Proposal for Supplement 13 to the 04 series of amendments to Regulation No. 44 (Child Restraint Systems)

Submitted by the expert from the Netherlands*

Figures of Strapped child

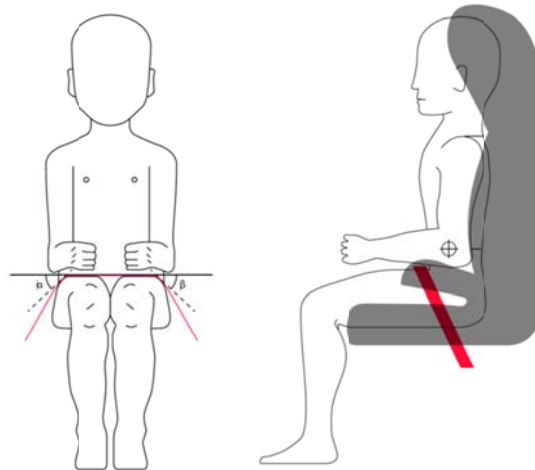
"6.2.2. ~~For groups I, II and III,~~ All restraint devices utilizing a "lap strap" shall positively guide the "lap strap" **on both sides** to ensure that the loads transmitted by the "lap strap" are transmitted through the pelvis. The assembly shall not subject weak parts of the child's body (abdomen, crotch, etc.) to excessive stresses. "

In the case of booster cushions and booster seats , the lap portion of the adult seat belt shall be positively guided on both sides to ensure that the loads are transmitted by the adult lap belt are transmitted through the pelvis. The positive guidance of loads over the pelvis shall be realised from the moment that the child is installed; the lap belt shall pass over the proximal of the top of the thigh, just touching the fold with the pelvis. The angles α and β between the tangent line in which the belt touches the thighs and the horizontal shall be greater than 10° ."

Three-point retracting belt dynamic test

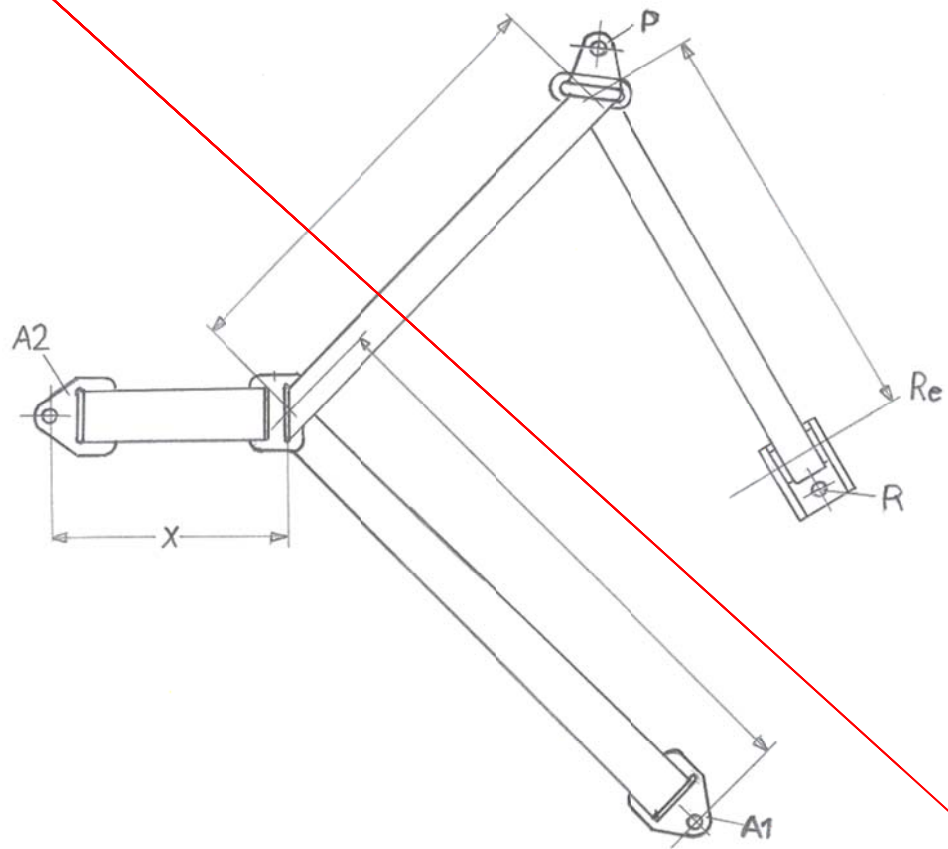
Figure 1B, amend to read:

Figure 1C
Standard seat belt configuration, for fitting session of par.6.2.12.

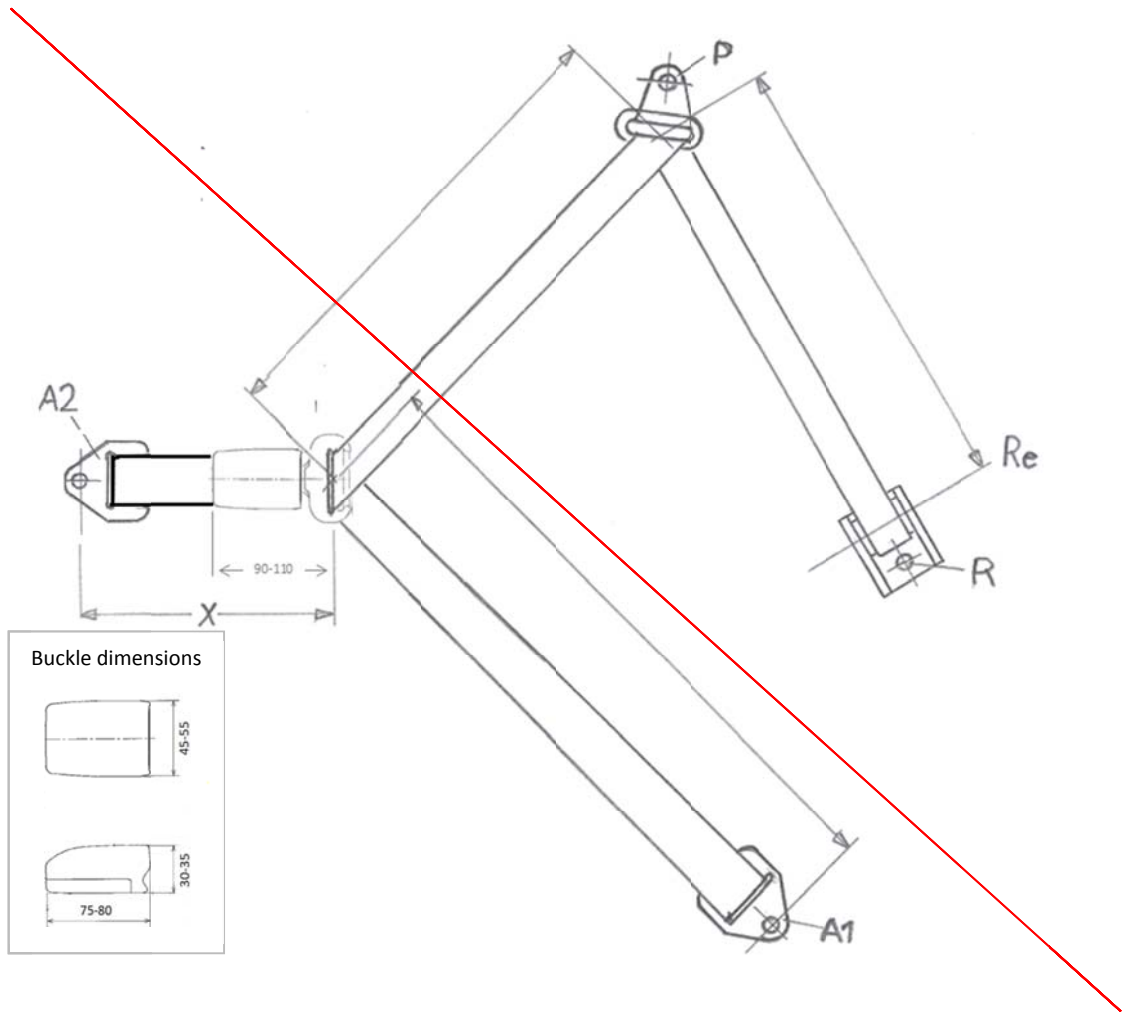
Insert new Figure 1C, to read:

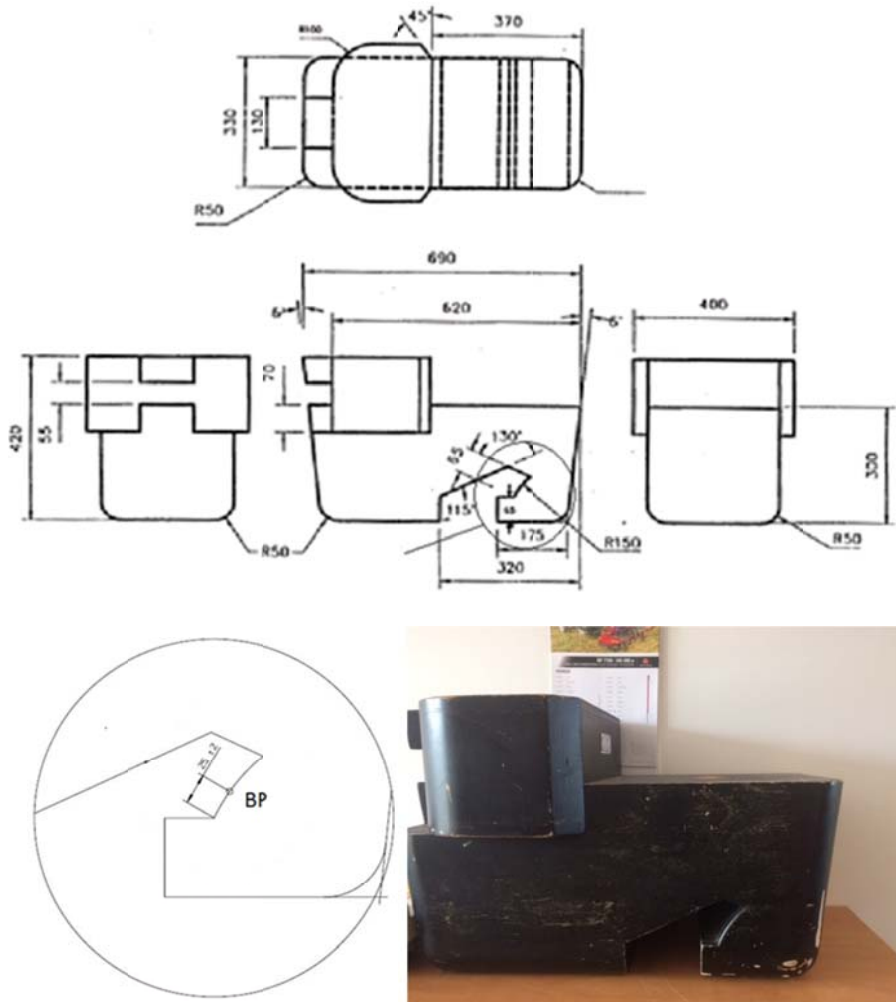
On par. 6.1.8., the item concerning the main load-bearing contact point:

Related to paragraph 6.1.8. in Reg.44 exists a complementary set of paragraphs in Reg.16 (Annex 17, Appendix 1 - Provisions concerning the installation of "universal" category child restraint systems installed with the safety-belt equipment of the vehicle). The intention of both is to guarantee compatibility. Firstly, Reg.16 allows car manufacturers a certain zone where their buckle and tongue may protrude; a "fixture" often called gabarit is used to check this.

RDW has been confronted with the following incompatibility. Here the belt may be on a distance of 150 mm, but within the zone of 150 mm is the red webbing guide of the CRS and this CRS part can touch the car buckle-tongue combination in such a way to hinder proper restraining and cause also detrimental effects by hard-hard contact.

The new proposal for par. 6.1.8. brings the CRS requirements closer to the complementary car requirements and should prevent misinterpretations.
